**E-54 Regional Lift Station - RFCSP
Solicitation Number: CO-00537
Job No.: 22-2502**

**ADDENDUM 5
November 2, 2022**

SAWS JOB NO.	22-2502
JOB NO.	11500-51
DATE	MAY 2022
DESIGNER	J.H.
CHECKED S.J.F.	DRAWN S.J.F.
SHEET	S2.2

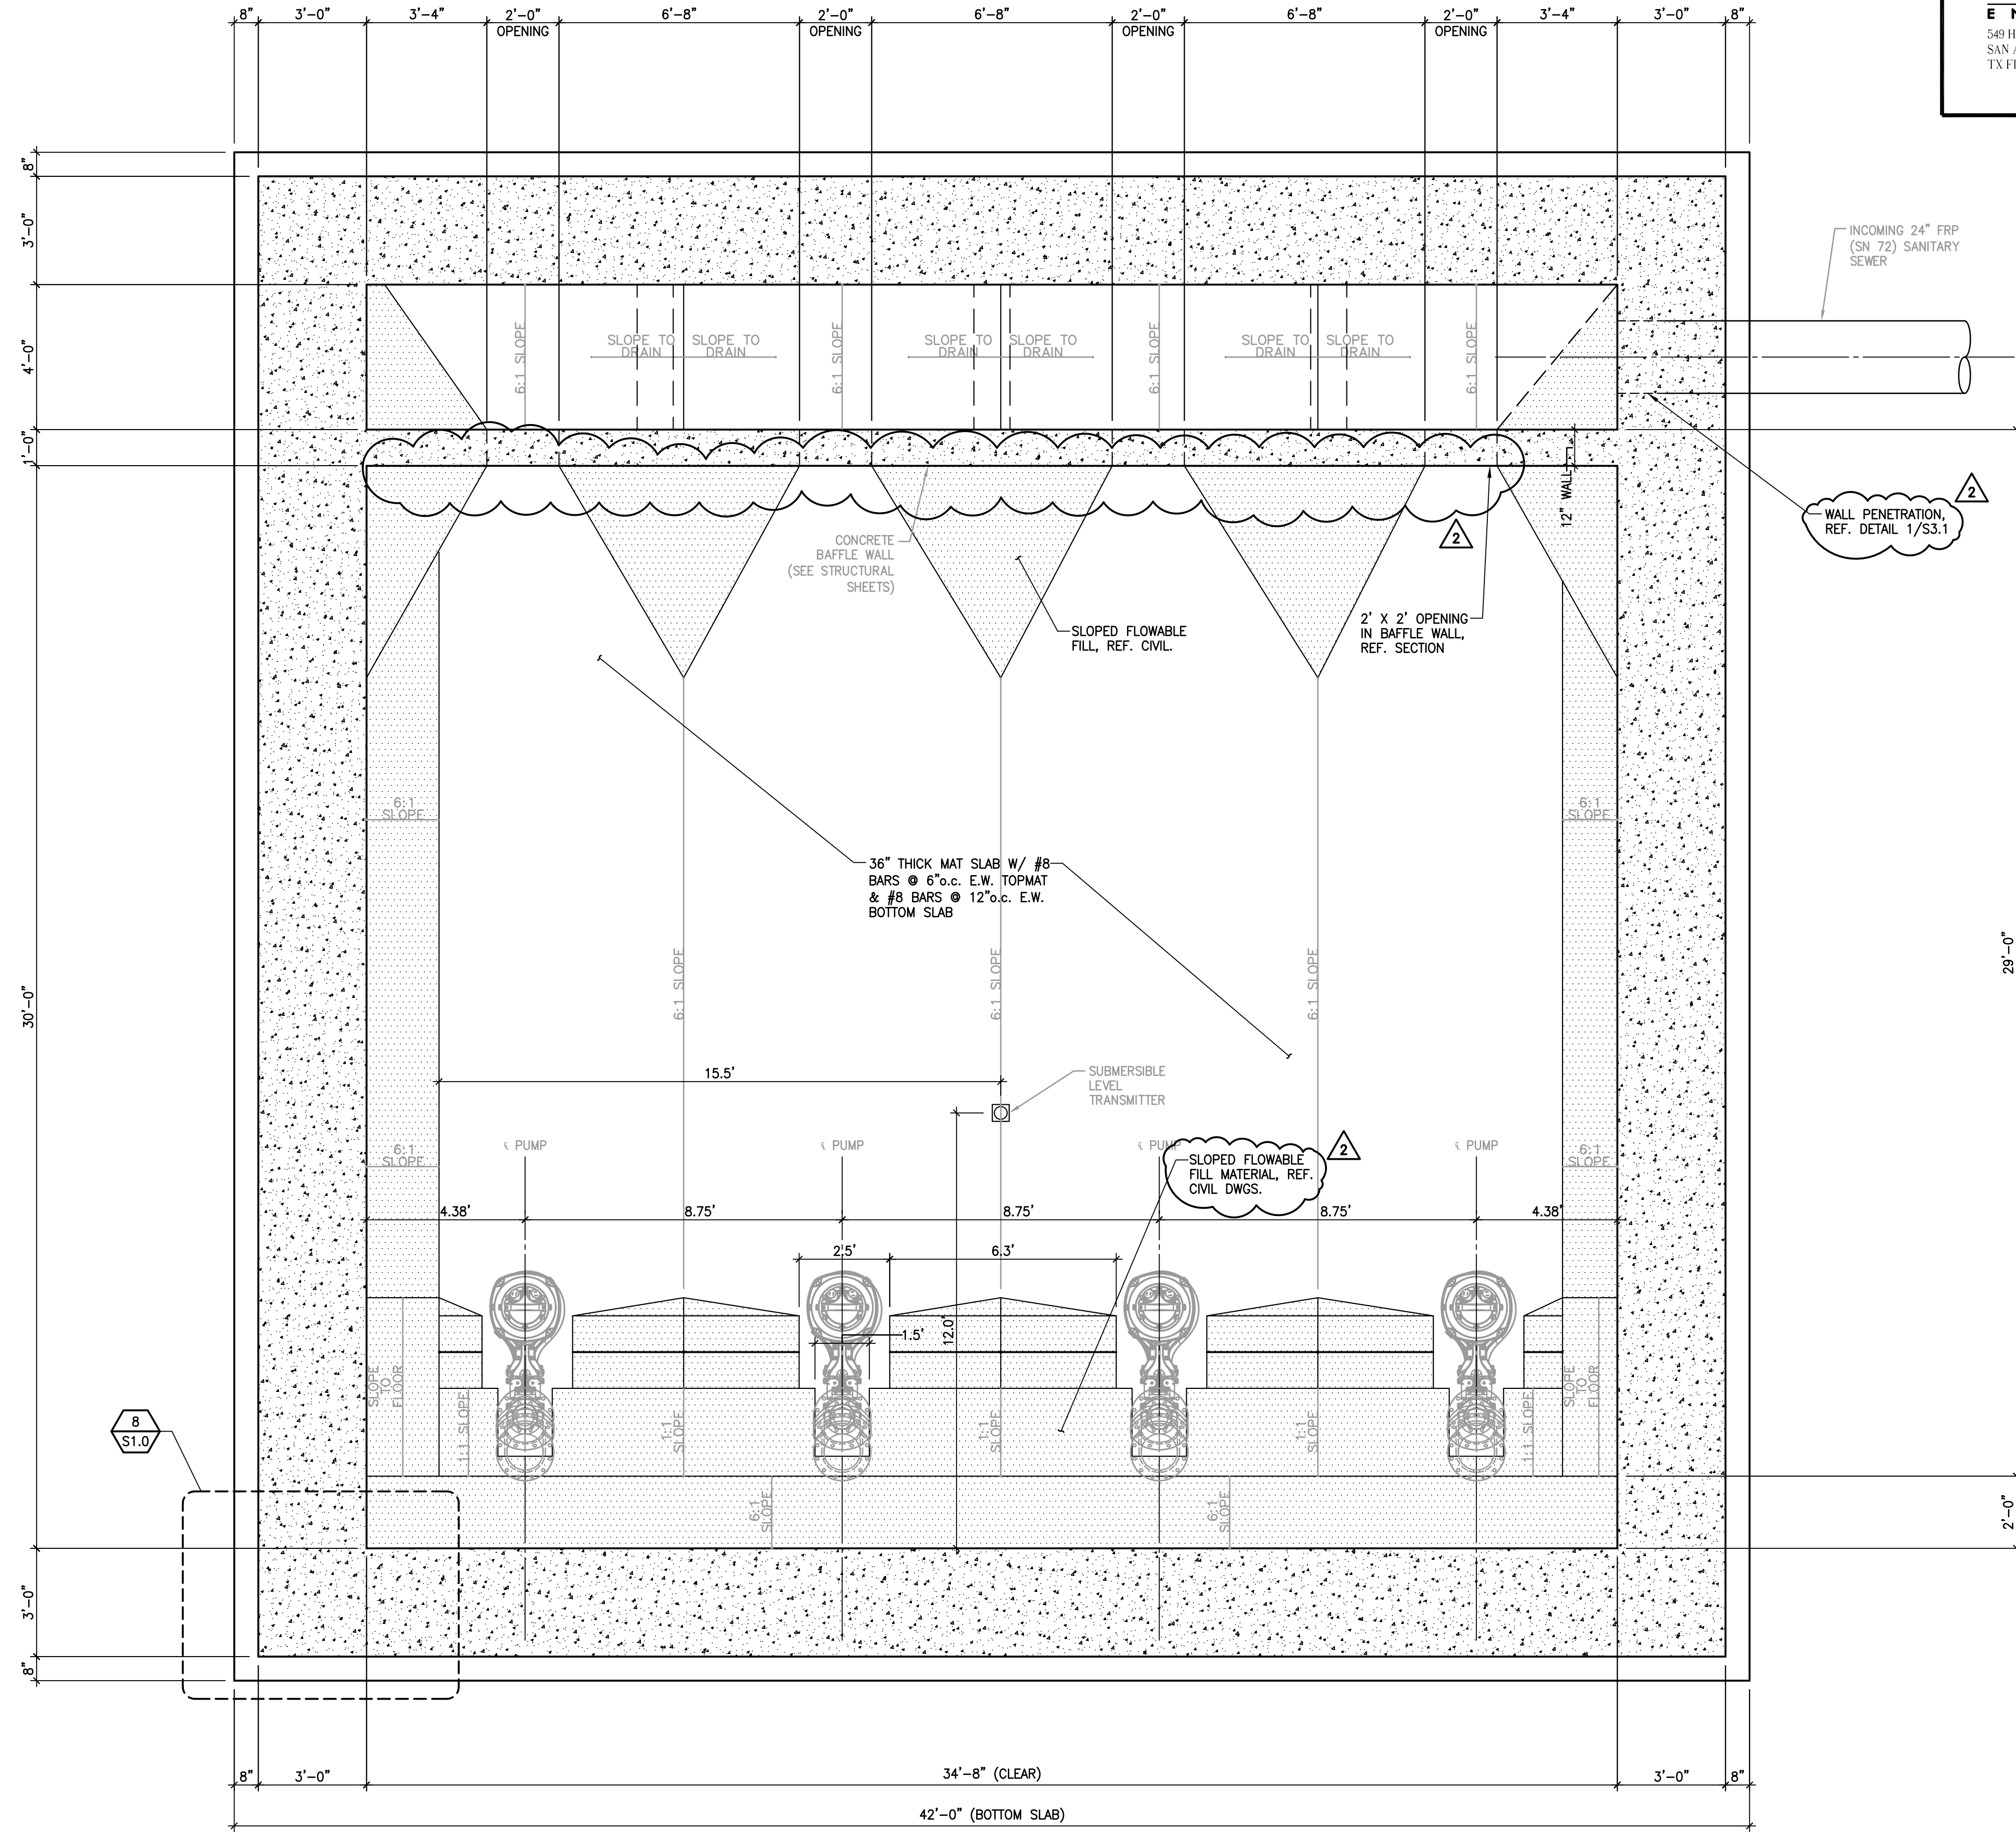
Sheet S2.2 calls out Beams GB- is below 12" wall, but not shown on section details.

RESPONSE: Grade beam signifiers at bottom slab were remnant of previous iteration of design. There are no grade beams below anything at the bottom of the wetwell. Sheet S2.2 – Wetwell Slab Plan is revised and attached in this Addendum. Please see Changes to the Plans #4.

SAWS JOB NO. 22-2502
JOB NO. 11500-51
DATE MAY 2022
DESIGNER J.H.
CHECKED S.J.F., DRAWN S.J.F.
SHEET **S3.0**

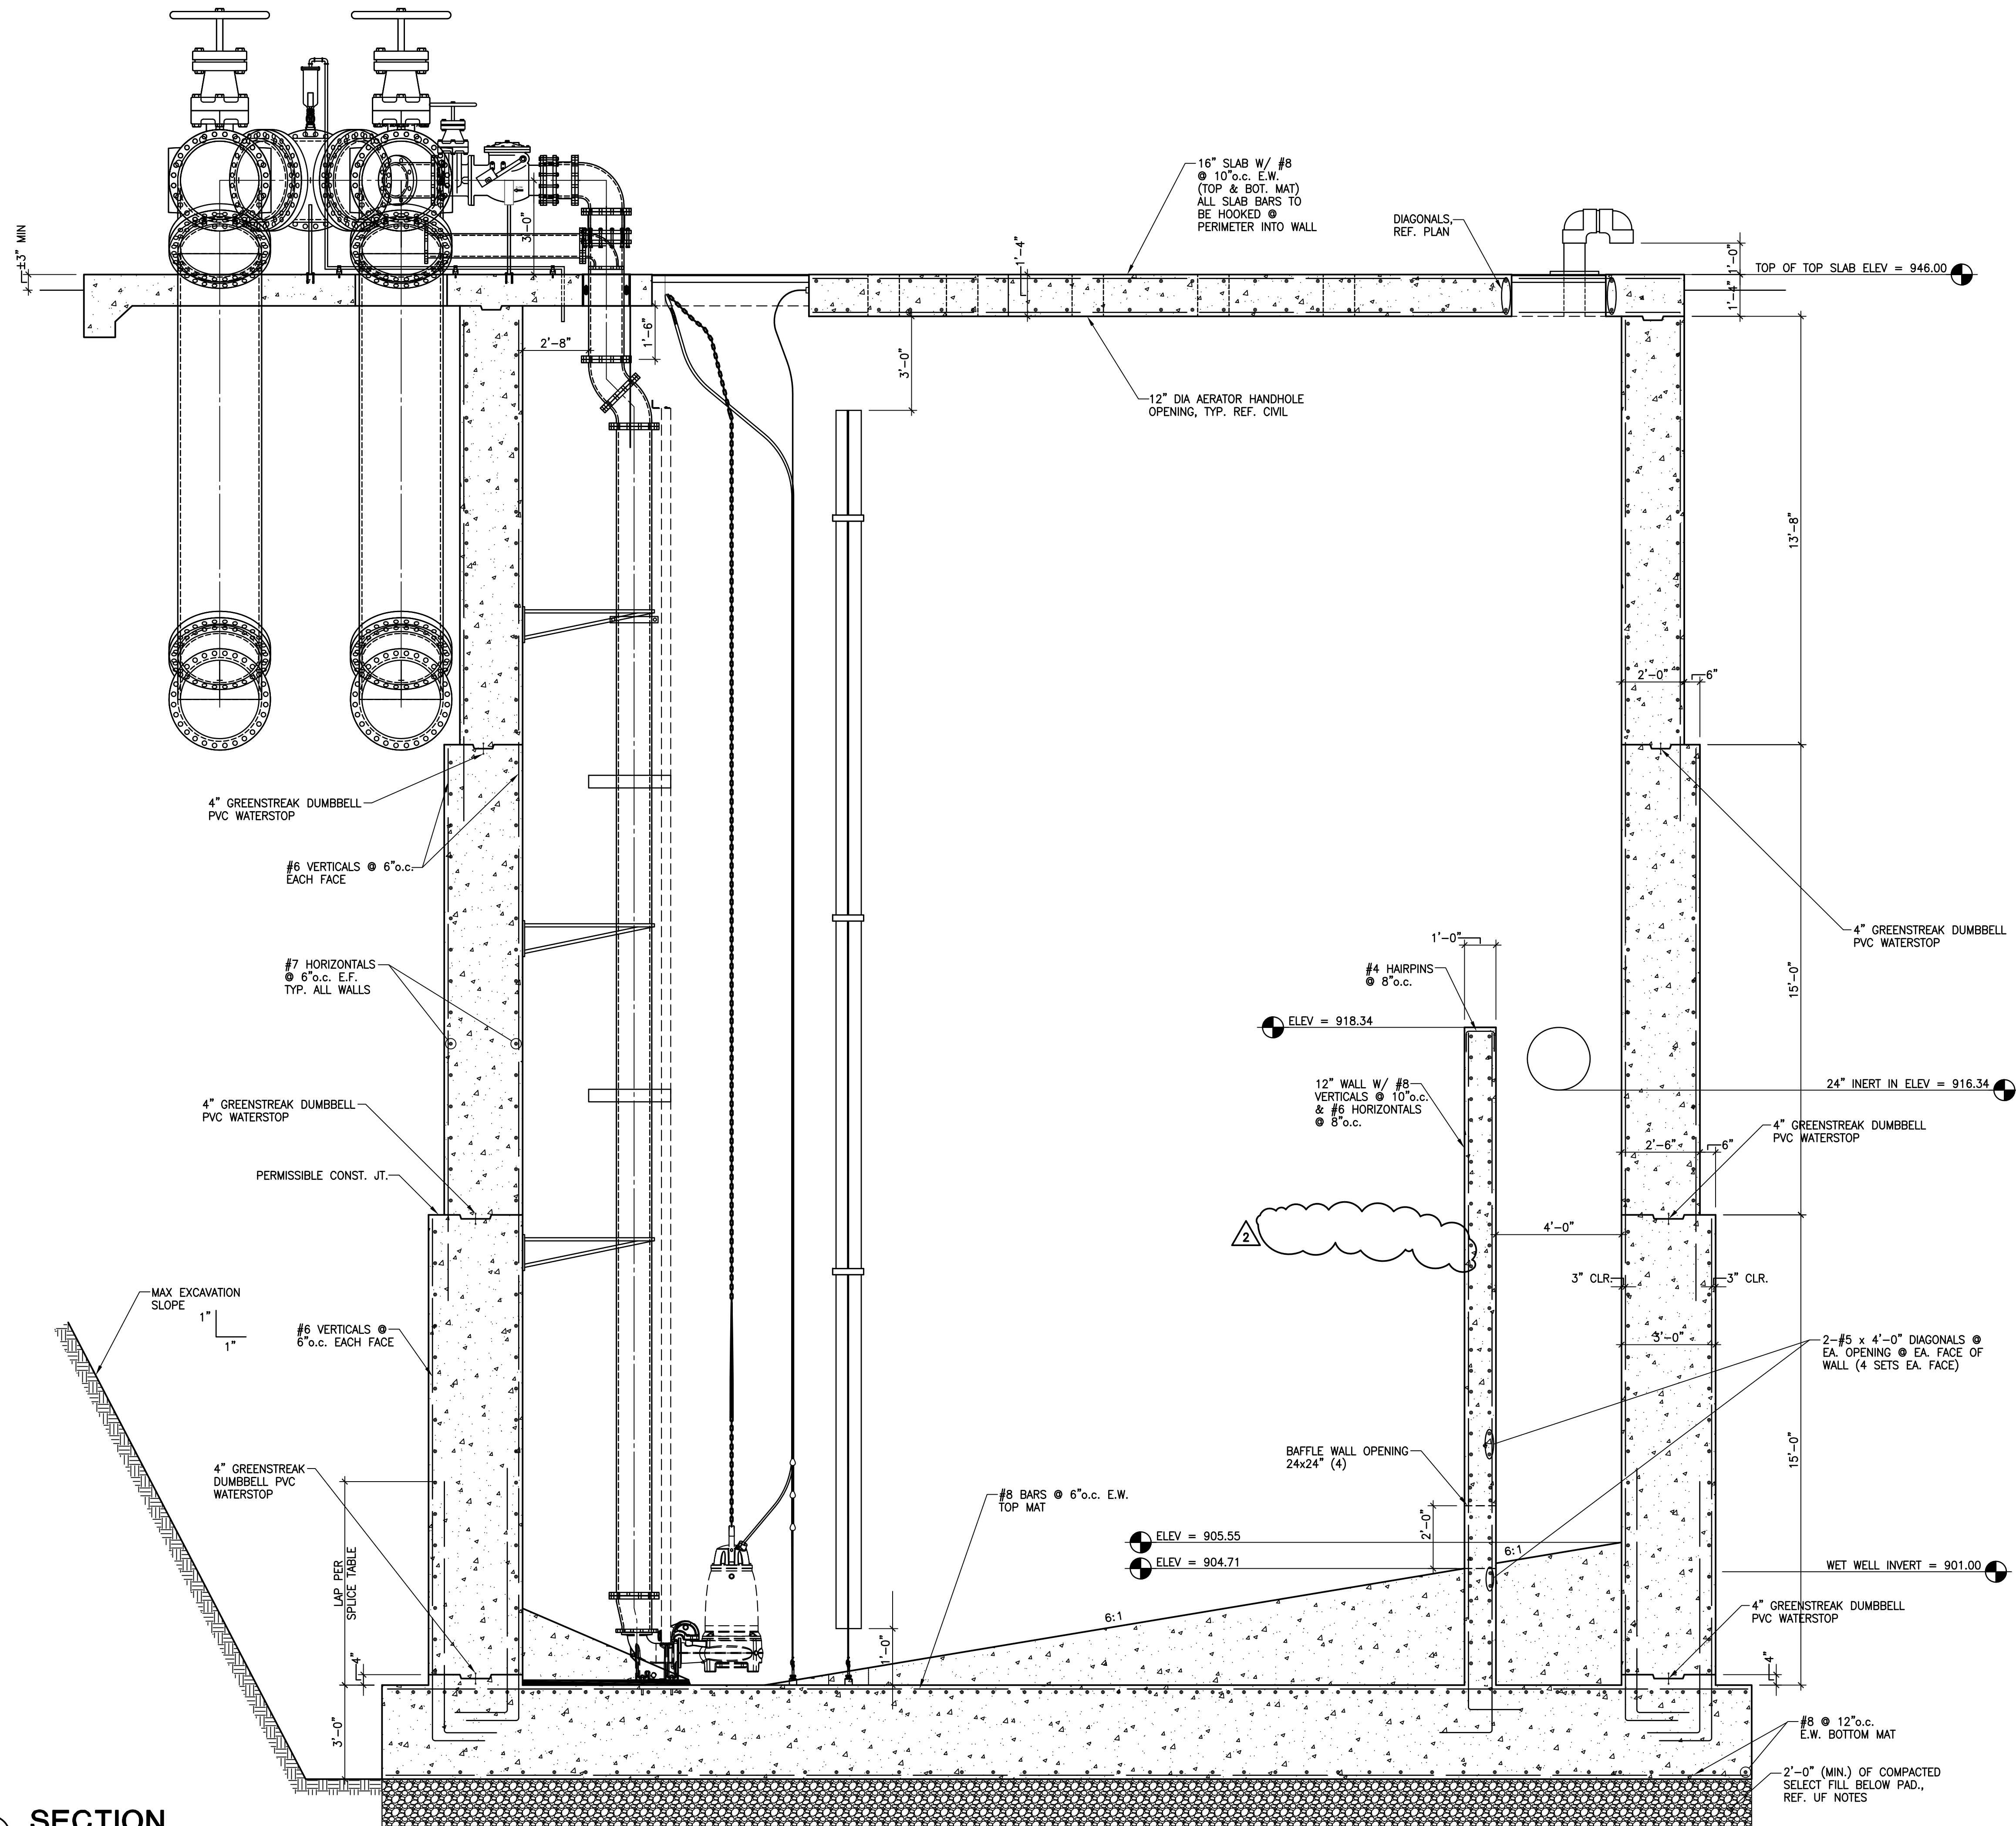
12" Baffle wall has 2 sets of rebar information shown – 1 set w/ #8 vertical bars @ 10" OC & #6 horizontal @ 8" OC and the other set shows the vertical bars as #6 @ 8" OC with the horizontals as #5 @ 8" OC.

RESPONSE: Removal of incorrect wall reinforcing callout has been completed. Incorrect reinforcing was remnant of last iteration of design. Sheet S3.0 – Section is revised and attached in this Addendum. Please see Changes to the Plans #5.
